JOB STAMP
 04-0120F4
 04-SF-80-12.6/13.2
 San Francisco Oakland Bay Bridge
 Self Anchored Suspension Span

REPORT NO.	865	to	871	DATE	Apr 26 – May 2, 2009	S T W Th F S
SHIFT HOUR	START	Var.	STOP	Var.	TEMPERATURE	
WEATHER	Sunday	Monday –	Tuesday –	Wednesday –	Thursday –	Friday – Saturday –

SUB 915 COMMENTS Dated: 28-Apr-09

E2-SB1a

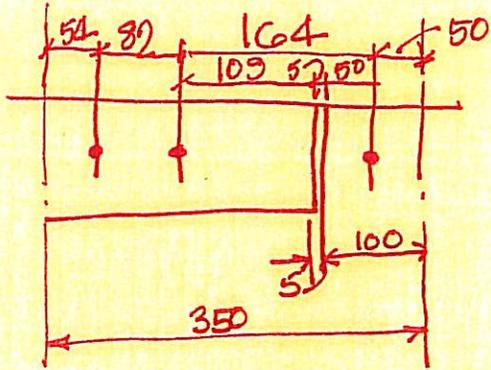
- **Deleted Bolt Holes:** In redlines, David indicated bolt holes at certain locations along the Steel Barrier had to be deleted in order to have adequate edge distance (*See Attachment of his comments*). He expressed that by deleting a bolt hole, the existing hole in the Deck Plate would have to be caulked. I reviewed his redlines contained in Submittal 915 and agree with his observation. Issue resolved with latest indicated redlines.

~~Sim~~ ~~W5-SB1~~

E2-SB1

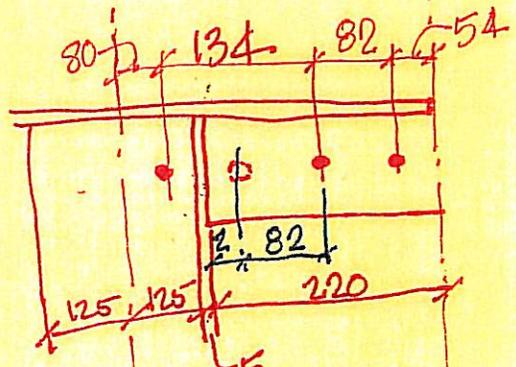
~~W5-SB1~~
Sim

W5-SB2

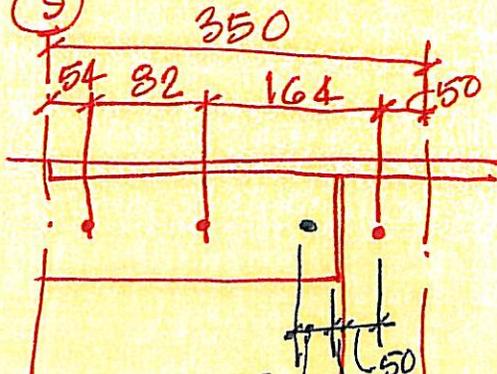
inadequate
edge
distance
